No: 044

Date: 22.10.93

Replacement Bridge Rectifier for 405 and 405-2 Amplifier

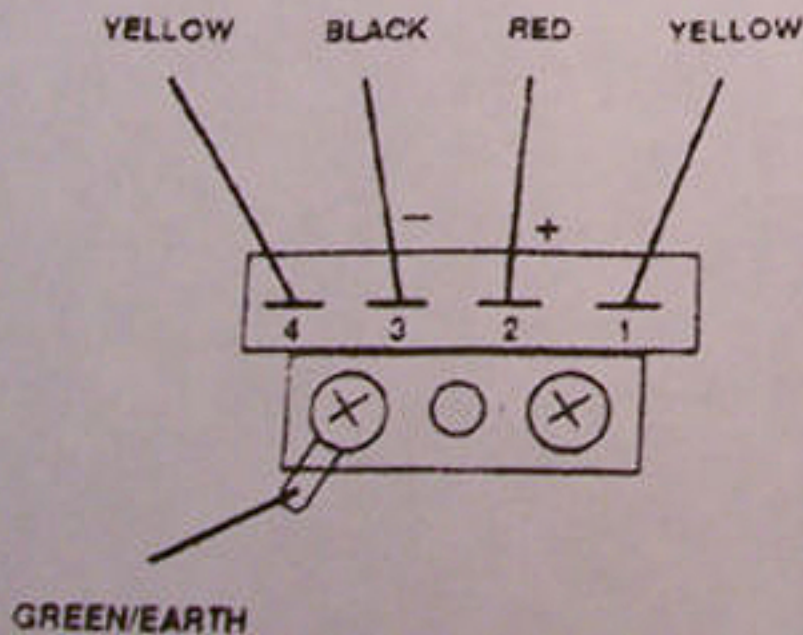
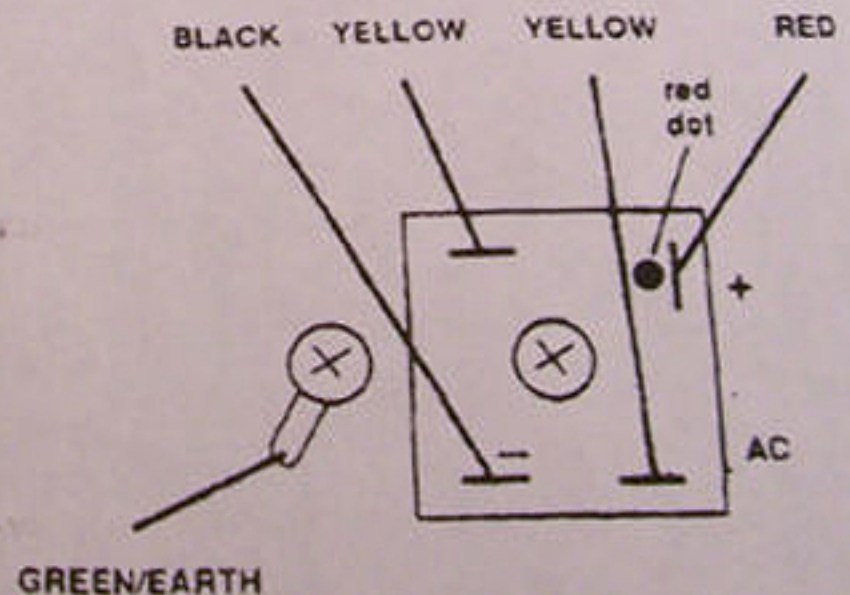
The original bridge rectifier type PM7A2Q is no longer available and has been replaced with type KBPC25-06 (MB256) - **part number DKB2506**. Fitting details as follows:-

1. Disconnect amplifier from power supply.
2. Remove top cover - two screws.
3. Cut wires from old rectifier - note connections and colours of wires.
4. Remove two fixing screws
5. Fit replacement using single fixing screw - the other screw being used for the earth tag fixing.
6. Restrip wires and reconnect as shown.
7. Test and refit cover

Wiring code: YELLOW = AC connection RED = positive BLACK = negative
